December 13, 2019

**Addendum No. 02
TO THE CONTRACT DOCUMENTS FOR:**

MANSFIELD FIRE STATION NO. 4

KAI Project No. 2016.166

01 FOUNDATION PLAN

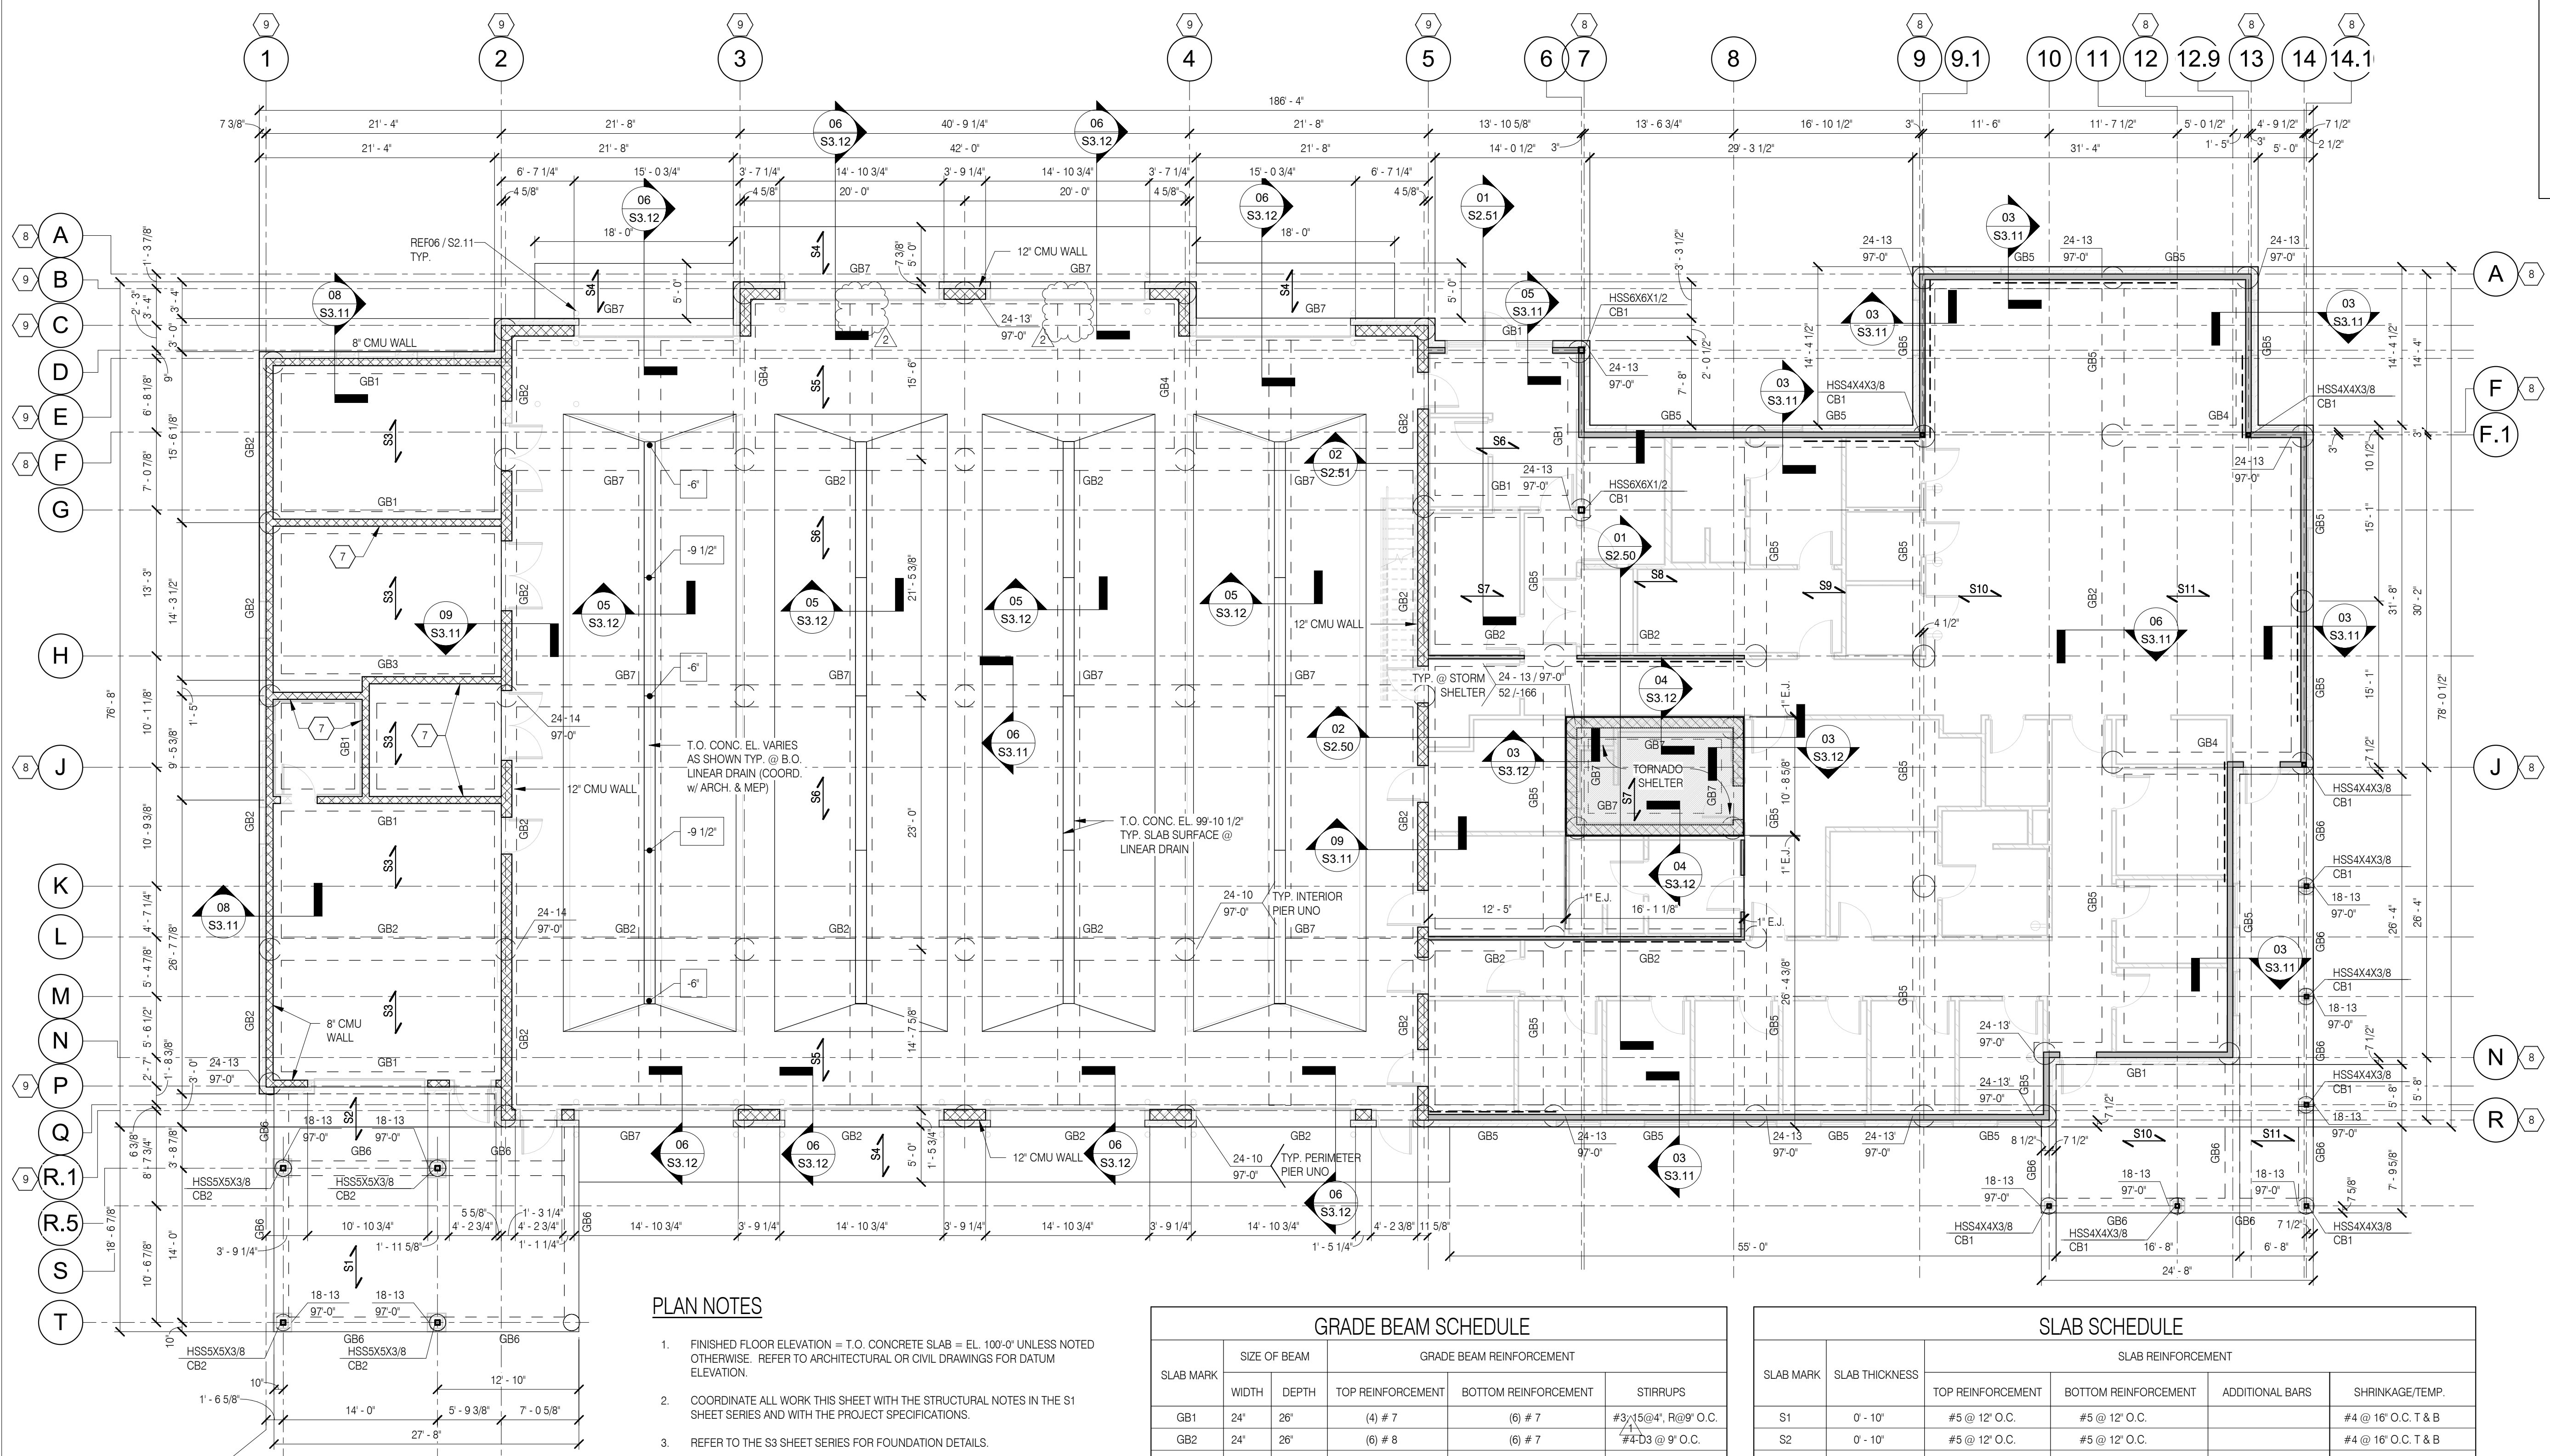
1. Sheet C5.0 – Revised sewer line.
2. Sheet C6.0 – Revised Gas and Fire line alignment.
3. Sheet A0.01 – See revised sheet to show drive revision to Holland Lane
4. Sheet A0.02 – See revised sheet for added dimension to 1/A0.02.
5. Sheet A1.01 – Added note 30.
6. Sheet A1.02 – Plan 2 – Clarified canopy dimensions and drainage. Added Note 7.
7. Sheet A4.06 – Detail 7 – Clarified Canopy fascia curb for canopy drainage.
8. Sheet A5.02 – Plan 2 – Revised size of Kitchen Island.
9. Sheet A5.03 - Omit B6 type accessory from project.
10. Sheet A5.06 – Elevation 12 and 17 – Revised width per island change.
11. Sheet S2.10 – Plan 1 – Revised grade beam in Bay. SLAB SCHEDULE – Revised bar sizes.
12. Sheet M0.02 – MULTI-ZONE DX SPLIT SCHEDULE revised.
